2 PROPOSED DETACHED DWELLINGS
ADDRESS :-
LAND TO REAR OF 59 FAR BANK, SHELLEY, HUDDERSFIELD
PROPOSED SITE LAYOUT AND SECTIONAL VIEW THROUGH PROPOSED ROADWAY.
SCALE 1:200 @ A2
2016/1/1/C

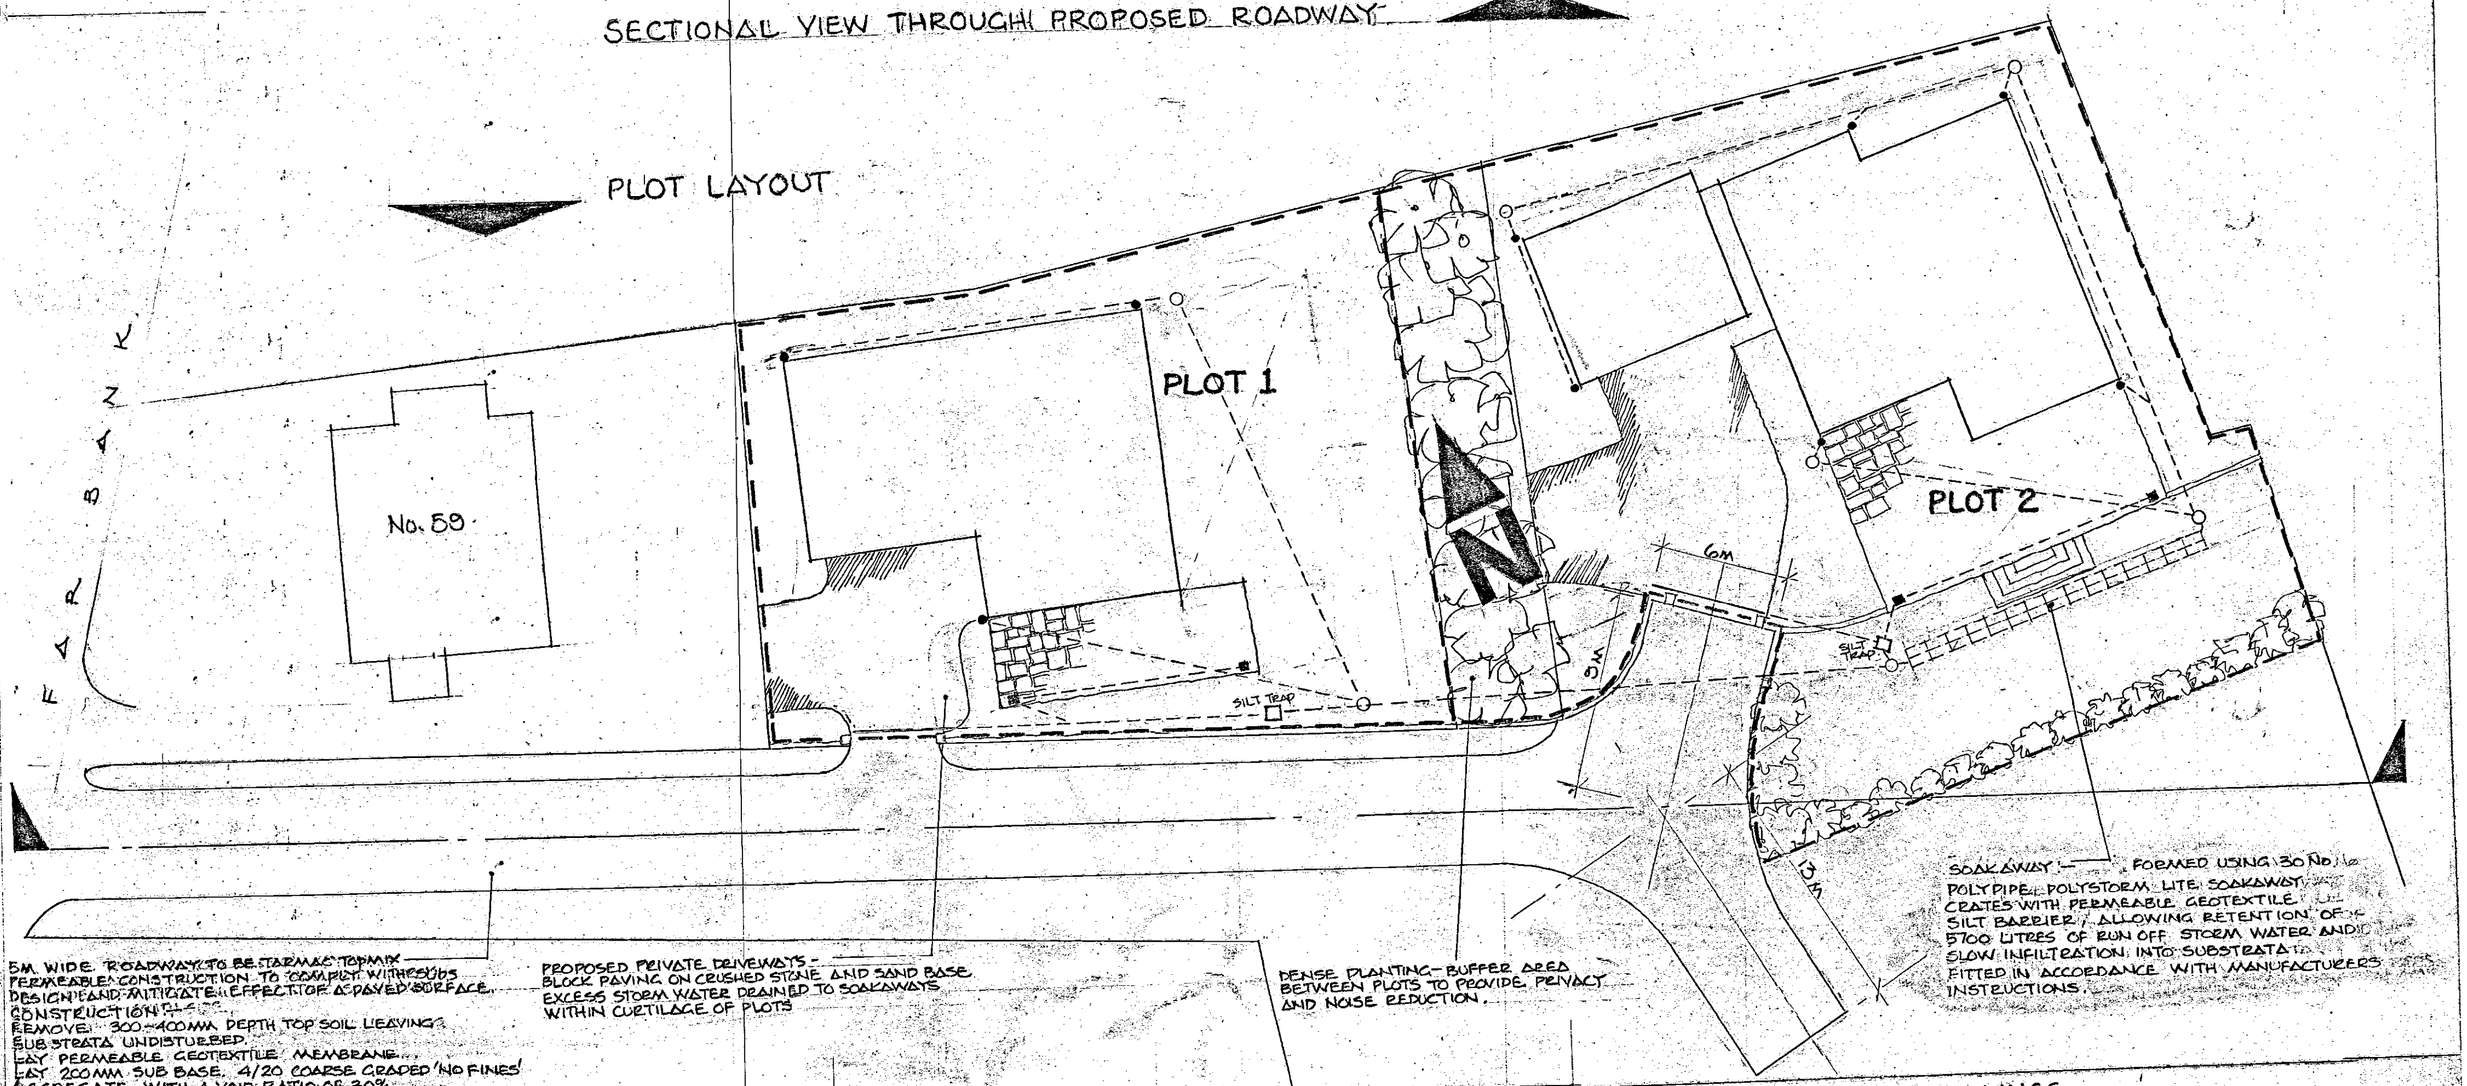
NOTES : AMENDMENT A : 2016/1/1/A - HIGHWAYS COMMENTS REGARDING TURNING HEAD FOR REFUSE VEHICLES, TURNING HEAD IMPROVED AND ENLARGED.
AMENDMENT B : 2016/1/1/B REVISED DRAWING TO SHOW AMENDED LAYOUT OF PLOT 2 AND SECTIONAL VIEW THROUGH PROPOSED ROADWAY SHOWING RELATIVE LEVELS OF PROPOSED DWELLINGS TO FAR BANK AND 59 FAR BANK.
AMENDMENT C : 2016/1/1/C :- DETAILS OF ACCESS ROADWAY ADDED. MATERIAL CHOICE AND CONSTRUCTION, NEGATES EFFECT OF PAVING, DRAINAGE CAPACITY REMAINS UNCHANGED FROM ITS PRESENT CAPABILITY. SOAKAWAY INFORMATION ADDED.
